September 7, 2023

Re: Comment Response Letter:
Rod and Wire Mill 2022 IM Report
Area A: Parcel A3
Tradepoint Atlantic
Sparrows Point, MD 21219

Figure
1

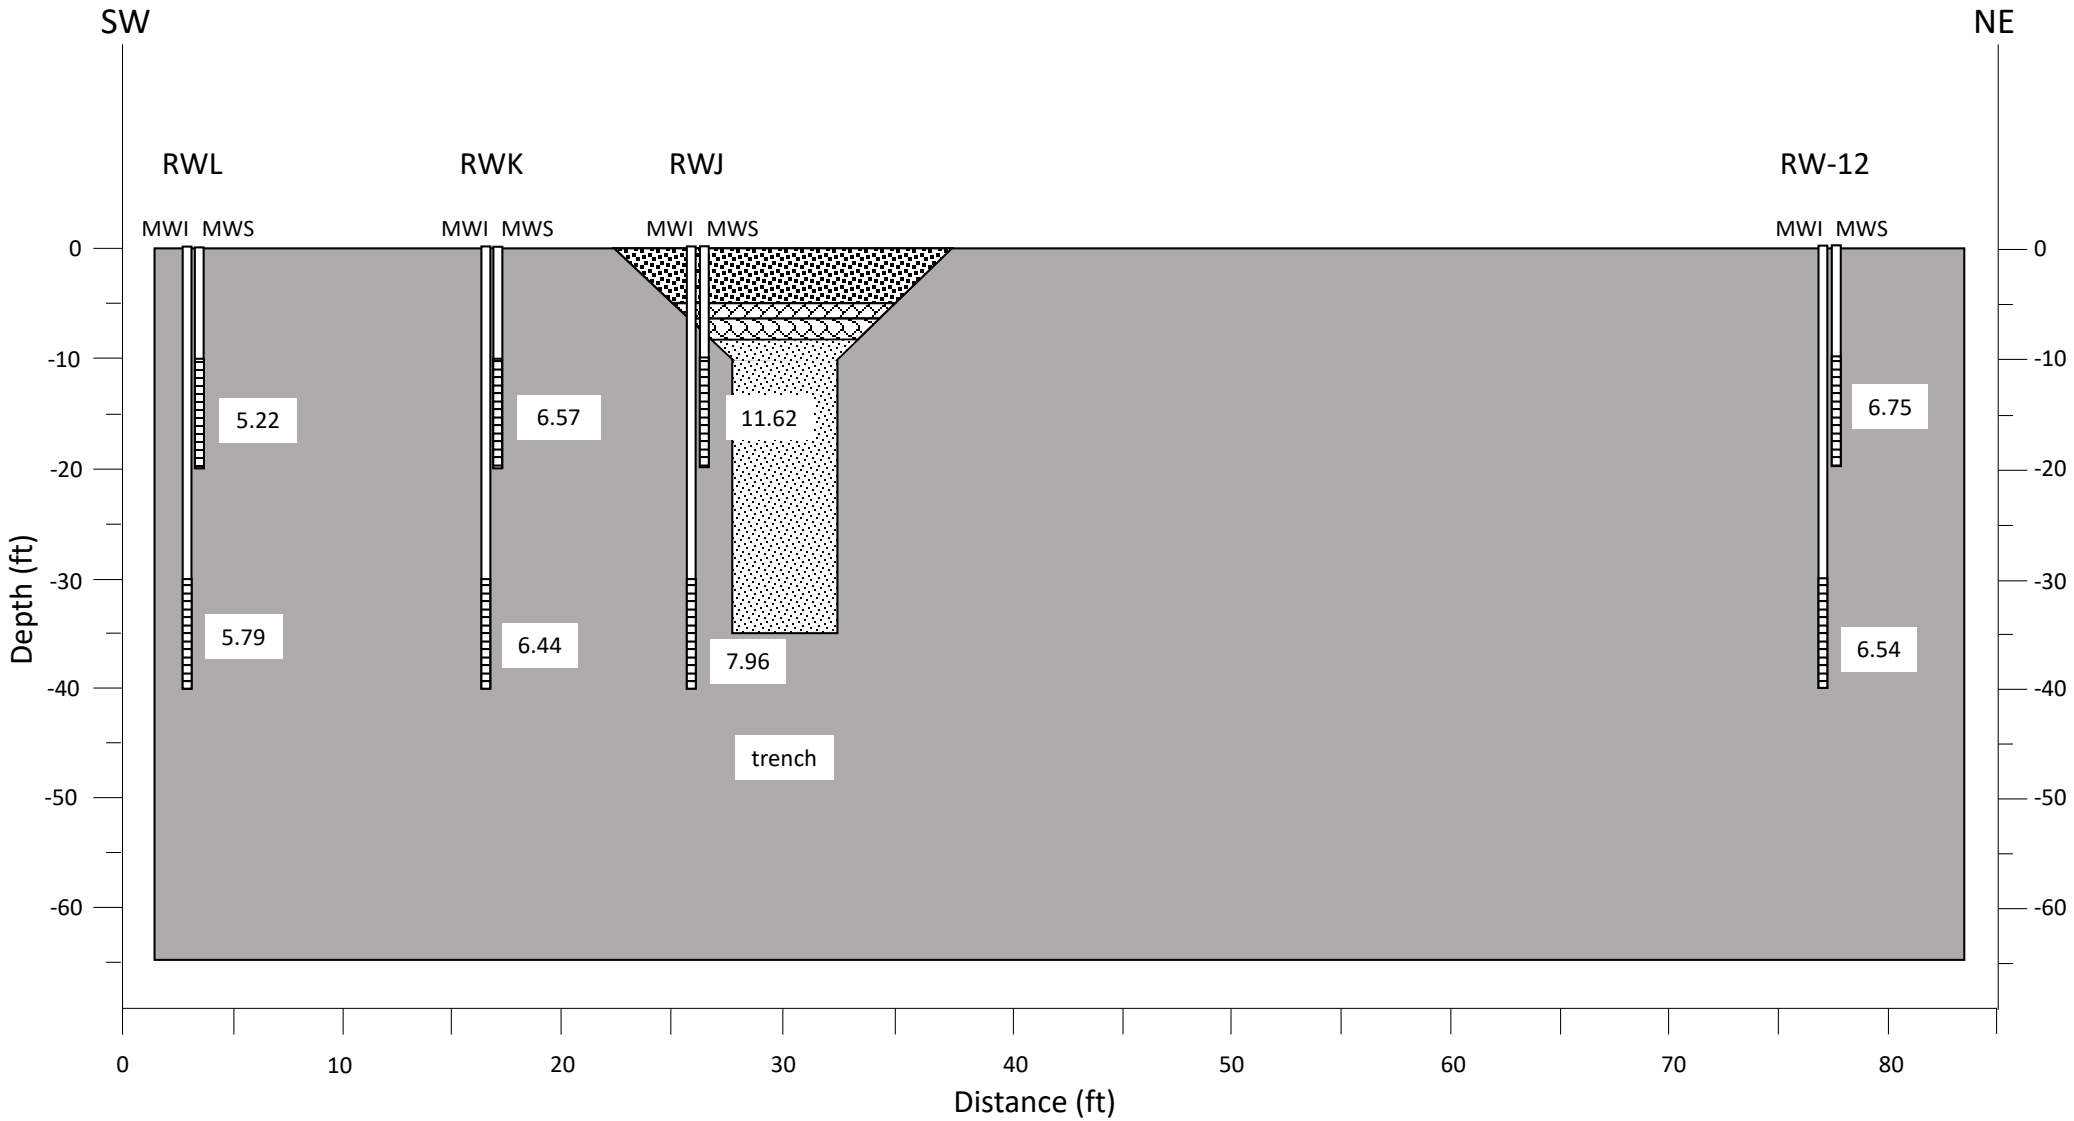
- *Zinc and cadmium concentrations in both RW03R-MWS and RW-03R-MWI showed substantial decreases from the last sampling event in RW03-MWS/I. Please confirm that*

the replacement well was installed co-located with the original well and show both well locations on a figure.

Response: The new wells were installed about 14 feet south of the original wells (based on GIS measurements of surveyed locations) – refer to Figure 1 attached to this CRL. The intermediate replacement well has the same screen interval as the original intermediate well (30-40' bgs). The shallow replacement well has a screen interval of 12-20' bgs compared to 10-20' bgs for the original.

Figure 2 - Rod and Wire Mill Cross Section - pH Values

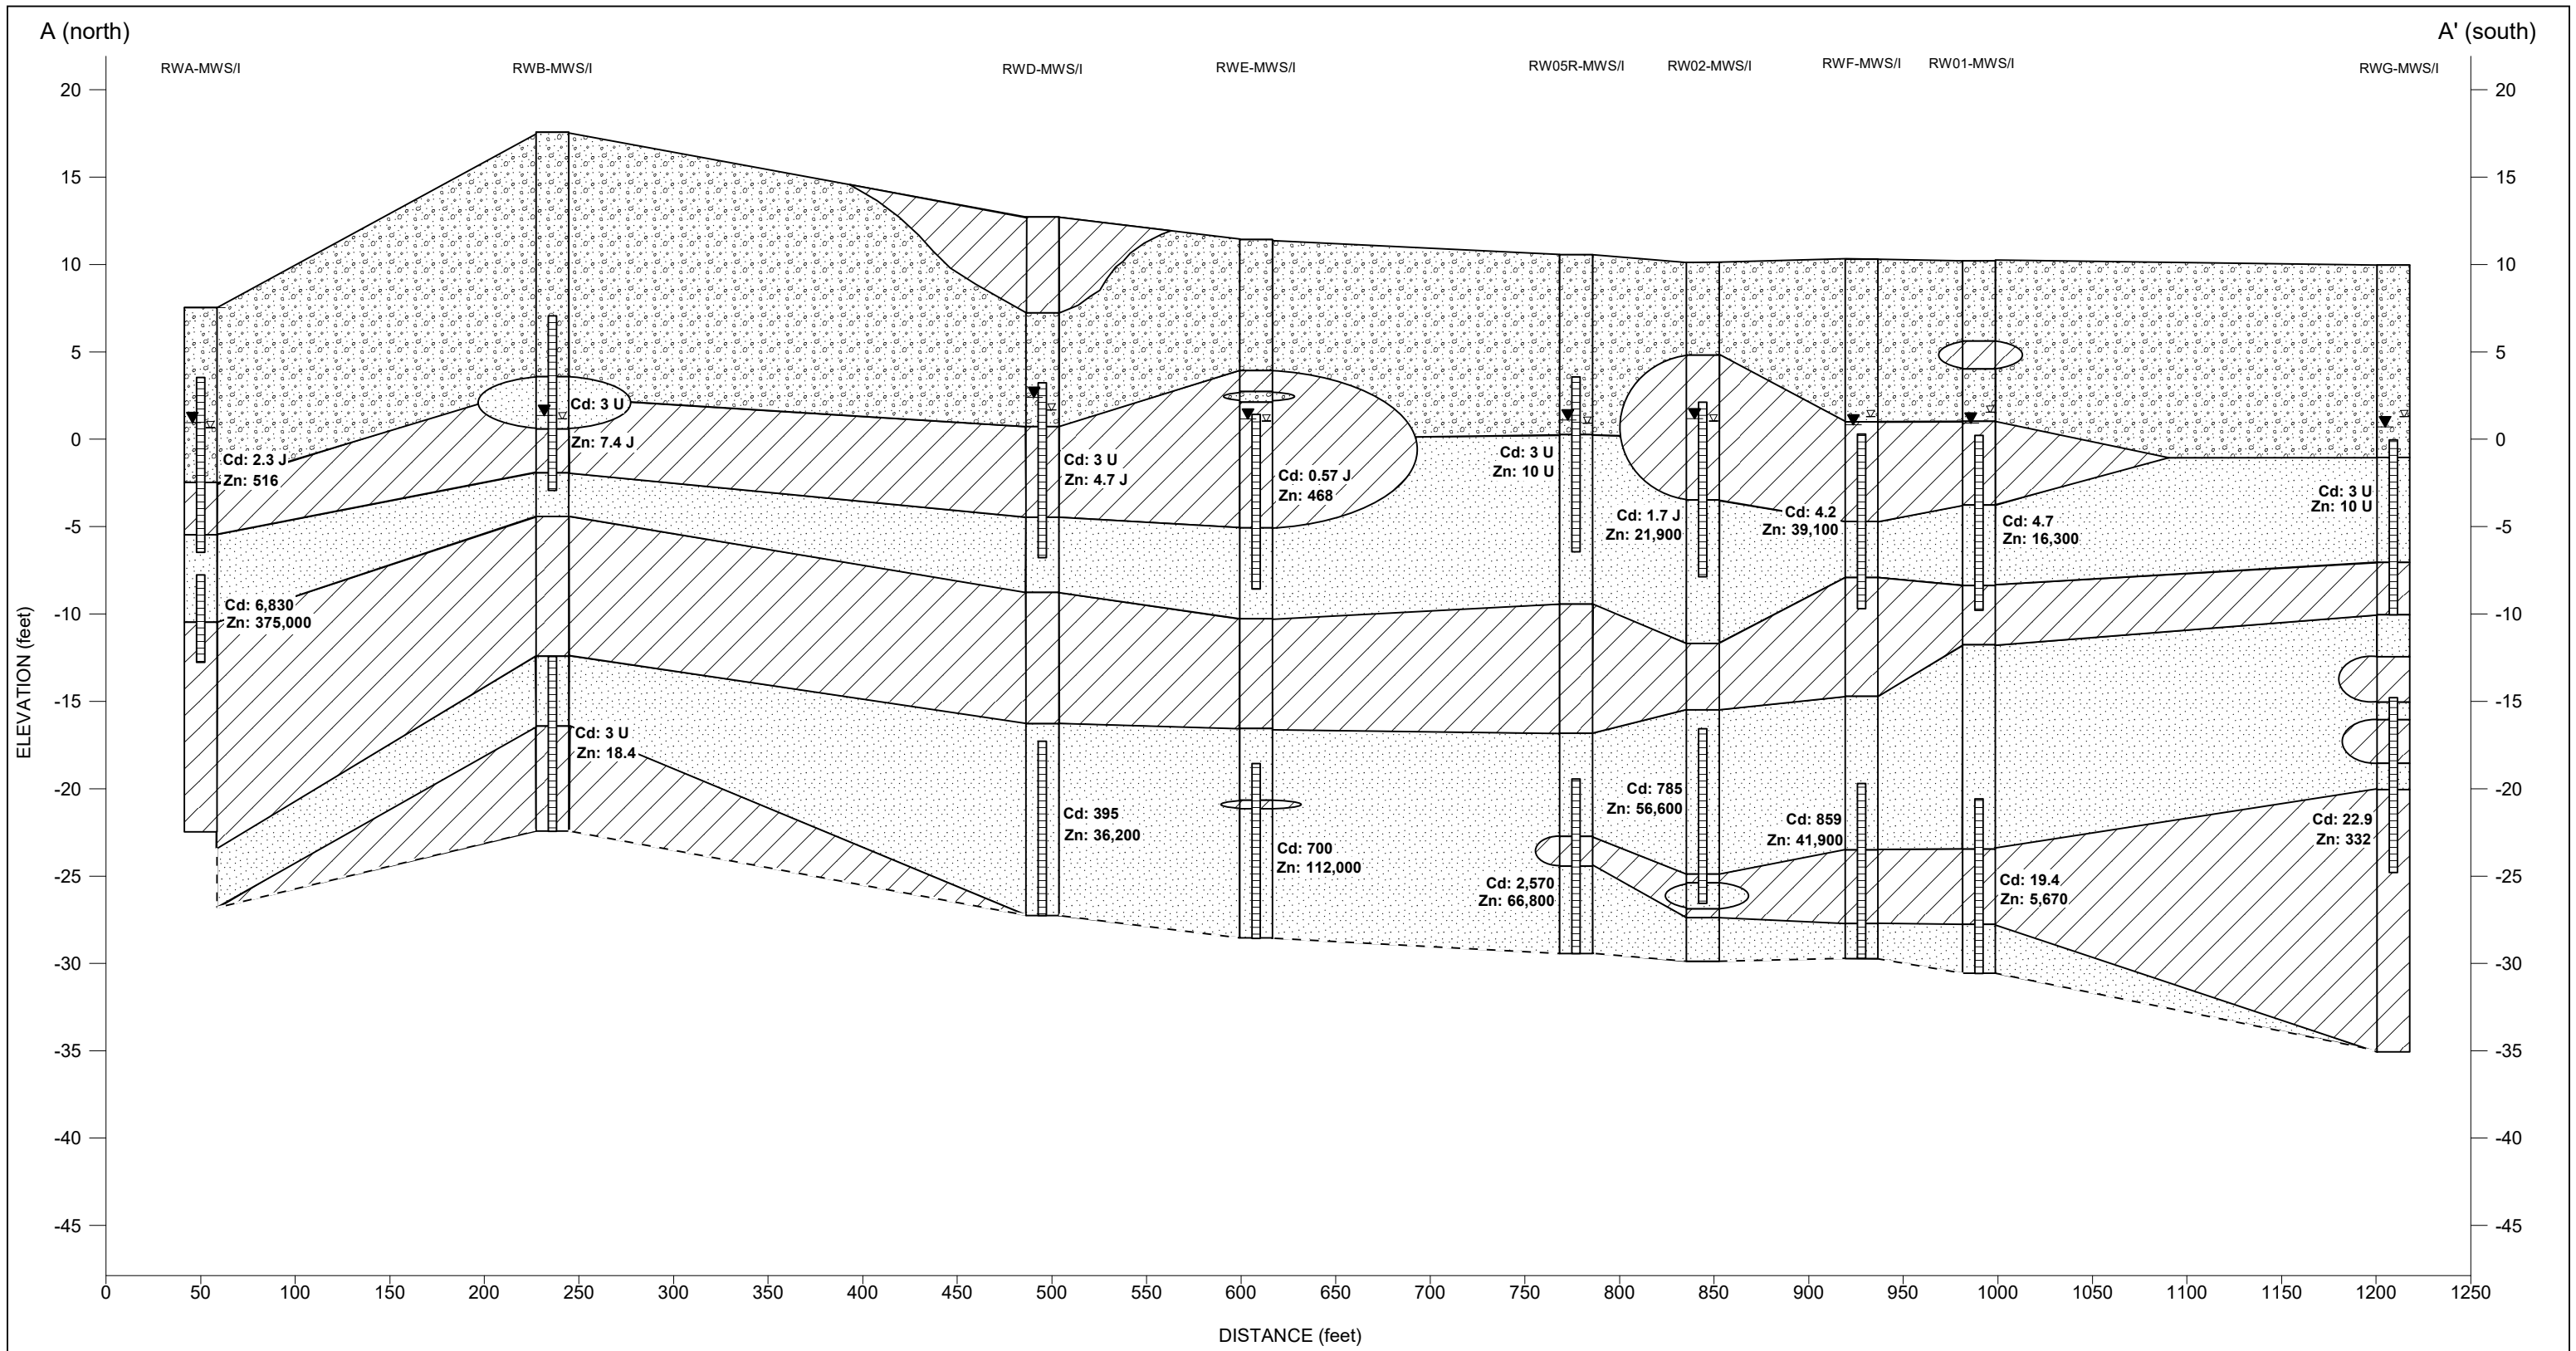
- *Please verify monitoring well RWJ-MWS/I was installed next to the trench. The figures show it being installed through the trench. Were the extents of the trenches surveyed?*

Response: Please note that the remediation trenches are wider at the top than at the base, so RWJ was installed through the top of the remediation trench but is screened adjacent to the remediation trench. Refer to the attached Figure 2 showing a cross section (previously included in the 2020 IM Report). A formal survey of the trench extent is not available.
